## Incorrect Coach Battery Cable Installation

<b>Bulletin Type:</b>	Recall	<b>Publication Date:</b>	September 2024
<b>Bulletin #(s):</b>	24V-577 USA 2024-442 Canada	<b>Make(s):</b>	Entegra
<b>Job Code(s):</b>	9903611	<b>Model(s):</b>	<b>Aspire</b> (44B,44D,40P,44R,44W,44Z)
<b>Flat Rate(s):</b>	9903611A .50 HR Inspect routing and re-torque of battery cables 9903611B .10 HR per battery cable replacement		<b>Anthem</b> (44B,44D,37K,44R,44W) <b>Cornerstone</b> (45B,45D,45R,45W,45Z) <b>Reatta</b> (39BH,39T2,37K) <b>Reatta XL</b> (40Q2,39BH,39T2,37K)
		<b>Model Year(s):</b>	2024-2025

<b>Incident:</b>	Battery cables may not be properly routed and torqued to specification
<b>Affected Units:</b>	2024-2025 units built between September 2023 to April 2024
<b>Parts List:</b>	N/A
<b>Misc. Tools &amp; Supplies:</b>	Torque Wrench with 12mm Socket

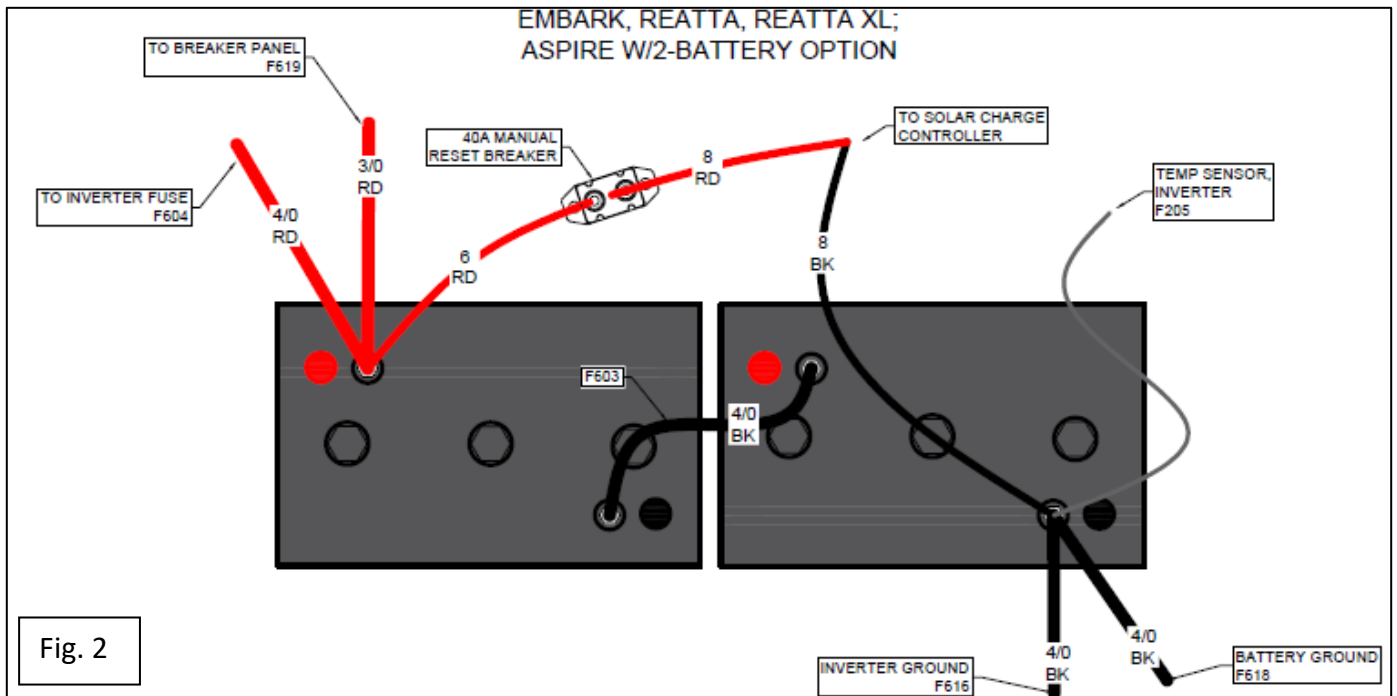
1. Verify battery cables are hooked up as shown and to proper torques specs.
  - A. Aspire with 4 Battery Option/Anthem & Cornerstone with AGM Option
    - i. Battery cable size (Figure 1)

- ii. Temp Sensor wire location
- iii. House battery terminals (Figure 1) **Torque = 150 IN-LB**
- iv. 40A Manual Reset Breaker (Figure 1) **Torque = 24 IN-LB**

QTY	PART #	DESCRIPTION
F602	2	0275480	CABLE,BTRY 1/0 GA BLK 13" .3125/.3125 RNG
F603	2	0275479	CABLE,BTRY 1/0 GA BLK 10" .3125/.3125 RNG
F604	1	2022826	CABLE,BTRY 4/0 GA RED 23.50 .3125/.5 RNG W/90DEG ROT
F618	1	0303753	CABLE,BTRY 4/0 GA BLK 65" .3125/.375 RNG
F619	1	0275467	CABLE,BTRY 3/0 GA RED 68" .3125/.3125 RNG

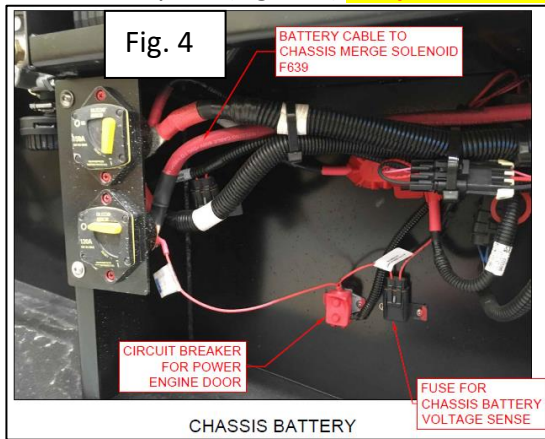
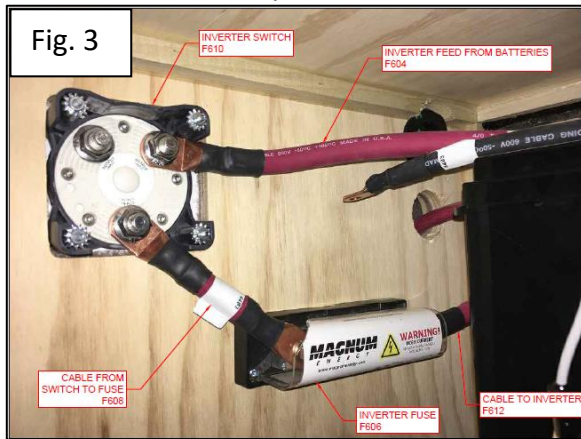
2. Verify cable connections at inverter fuse, inverter switch and battery disconnect terminals:
  - A. Inverter Switch (Figure 3) **Torque = 120 IN-LB**
  - B. Inverter Fuse (Figure 3) **Torque = 120 IN-LB**
  - C. Battery disconnect terminals within the battery box (Figure 4) **Torque = 50 IN-LB**

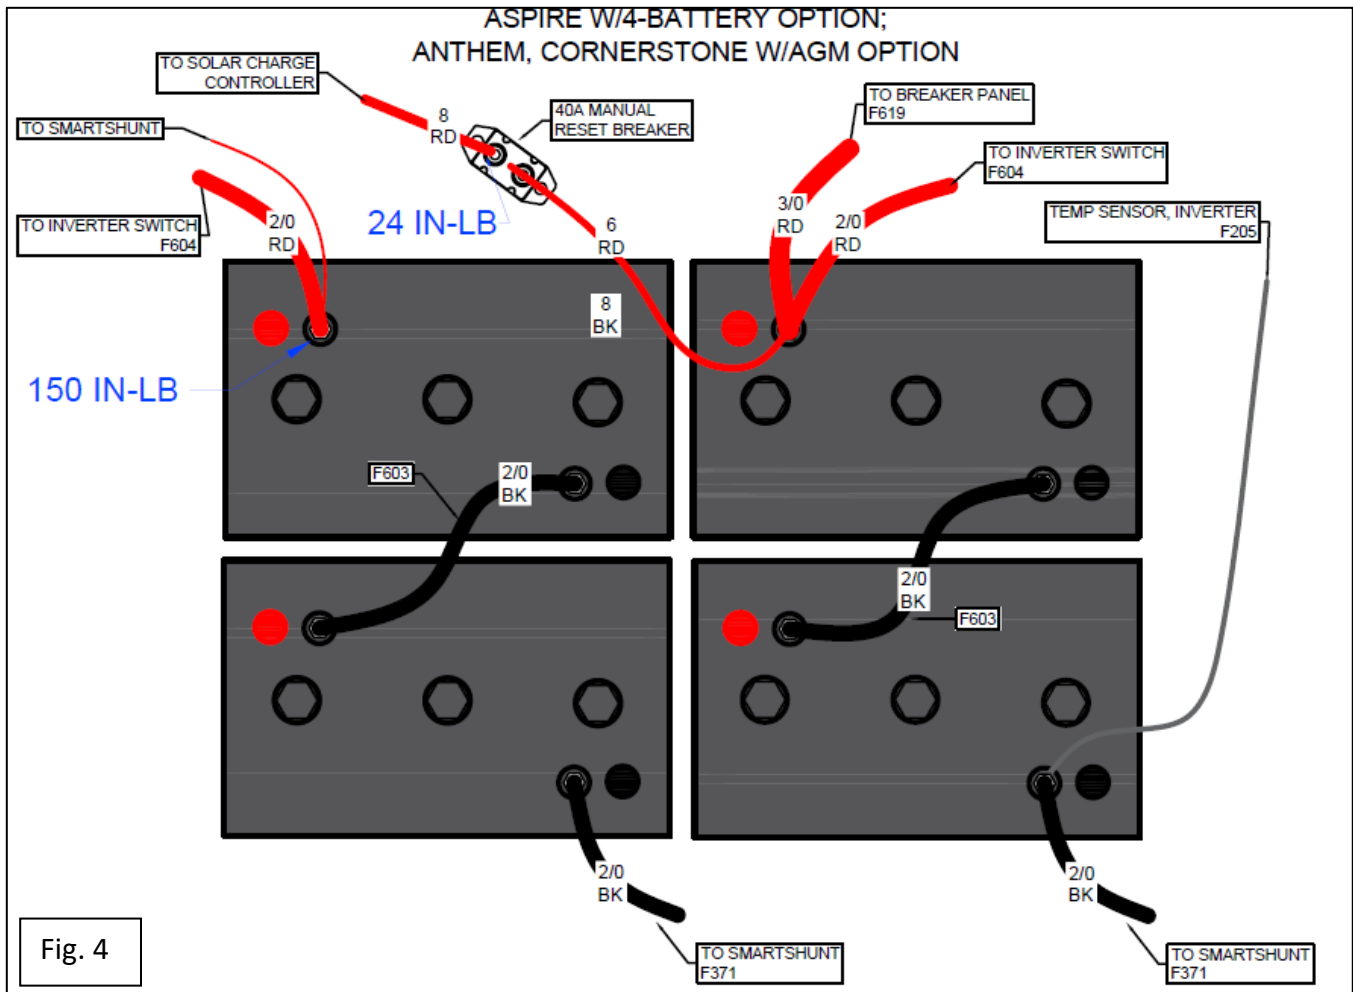
1. Verify battery cables are hooked up as shown and to proper torques specs.
  - A. Aspire with 4 Battery Option/Anthem & Cornerstone with AGM Option
    - i. Battery cable size (Figure 4)

- ii. Temp sensor wire location
- iii. House battery terminals (Figure 4) **Torque = 150 IN-LB**
- iv. 40A Manual Reset Breaker (Figure 4) **Torque = 24 IN-LB**

QTY	PART #	DESCRIPTION
F603	2	2057644	CABLE,BTRY 2/0 GA BLK 10" .3125/.3125 RNG
F604	2	2057650	CABLE,BTRY 2/0 GA RED 30" .3125/.5 RNG W/90DEG ROT
F371	2	2061524	CABLE,BTRY 2/0 GA BLK 47" .3125/.375 RNG
F619	1	0275467	CABLE,BTRY 3/0 GA RED 68" .3125/.3125 RNG

i. Battery cable size (Figure 5)

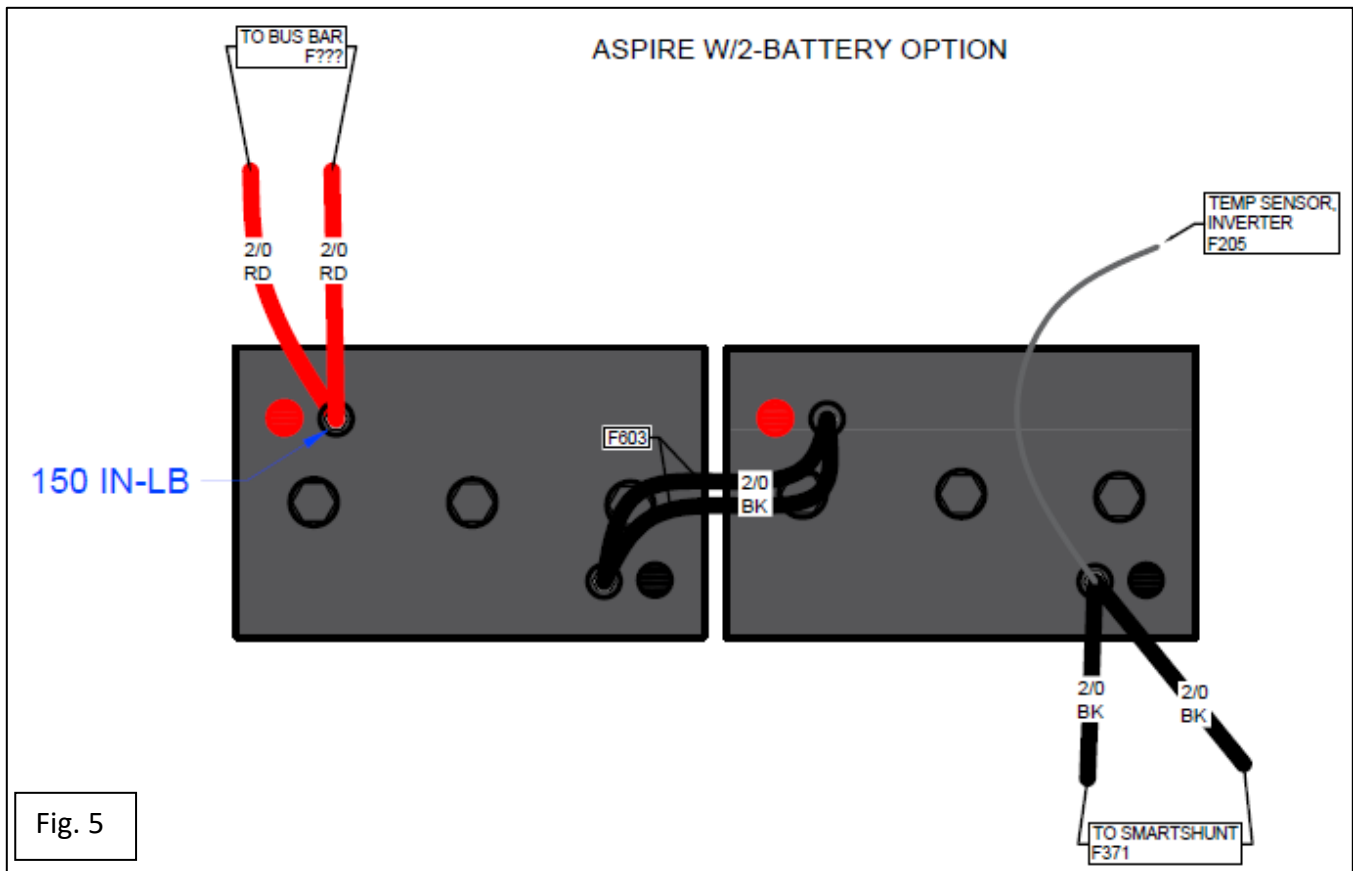
B. Aspire with 2 Battery Option

- ii. Temp sensor wire location
- iii. House battery terminals (Figure 4) **Torque = 150 IN-LB**
- iv. 40A Manual Reset Breaker (Figure 4) **Torque = 24 IN-LB**

QTY	PART #	DESCRIPTION
F603	2	2057644	CABLE,BTRY 2/0 GA BLK 10" .3125/.3125 RNG
F???	2	2057651	CABLE,BTRY 2/0 GA RED 8" .375/.5 RNG
F371	2	2061524	CABLE,BTRY 2/0 GA BLK 47" .3125/.375 RNG

v. Battery cable size (Figure 6)

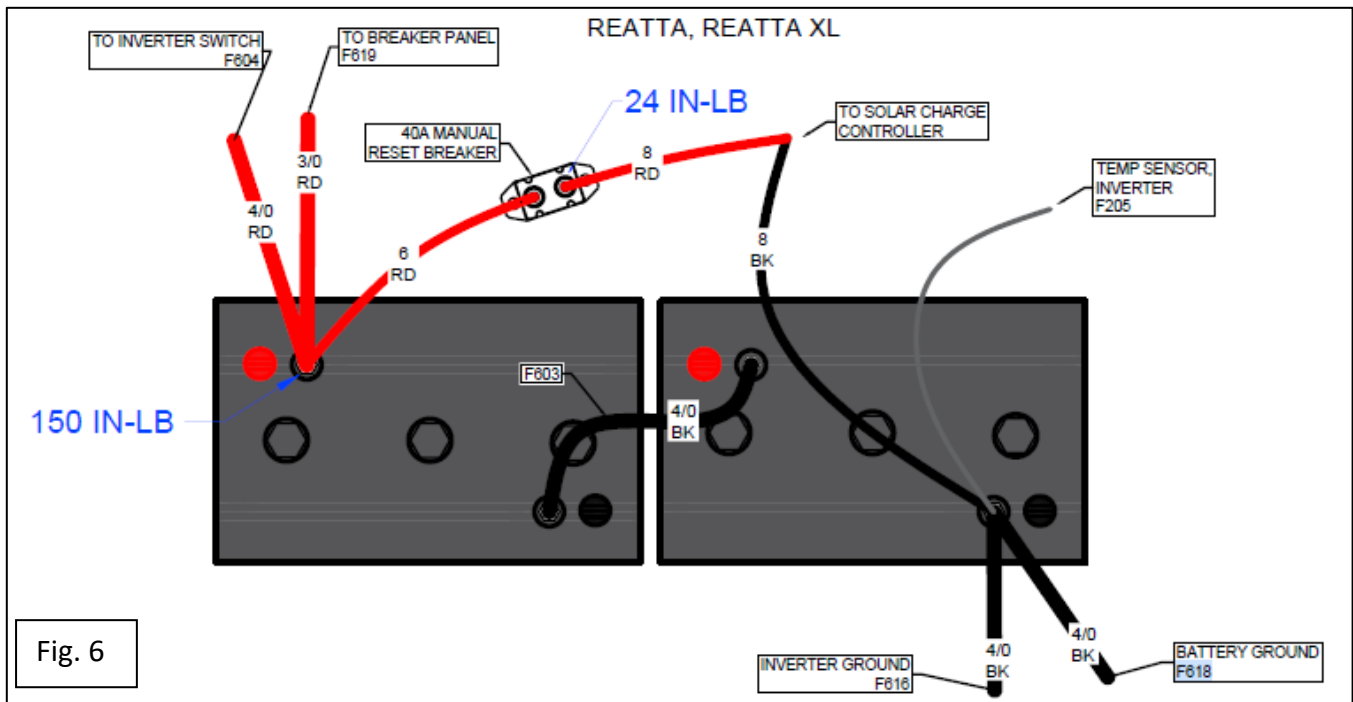
C. Reatta/Reatta XL

vi. Temp sensor wire location

vii. House battery terminals (Figure 4) **Torque = 150 IN-LB**

viii. 40A Manual Reset Breaker (Figure 4) **Torque = 24 IN-LB**

QTY	PART #	DESCRIPTION
F603	1	2029050	CABLE,BTRY 4/0 GA BLK 10" .3125/.3125 RNG
F604	1	2022825	CABLE,BTRY 4/0 GA RED 14.5" .3125/.375 RNG W/90DEG ROT
F616	1	0290230	CABLE,BTRY 4/0 GA BLK 68" .3125/.3125 RNG
F616	1	0290231	CABLE,BTRY 4/0 GA BLK 96" .3125/.3125 RNG
F618	2	0303753	CABLE,BTRY 4/0 GA BLK 65" .3125/.375 RNG
F371	2	0275467	CABLE,BTRY 3/0 GA RED 68" .3125/.3125 RNG
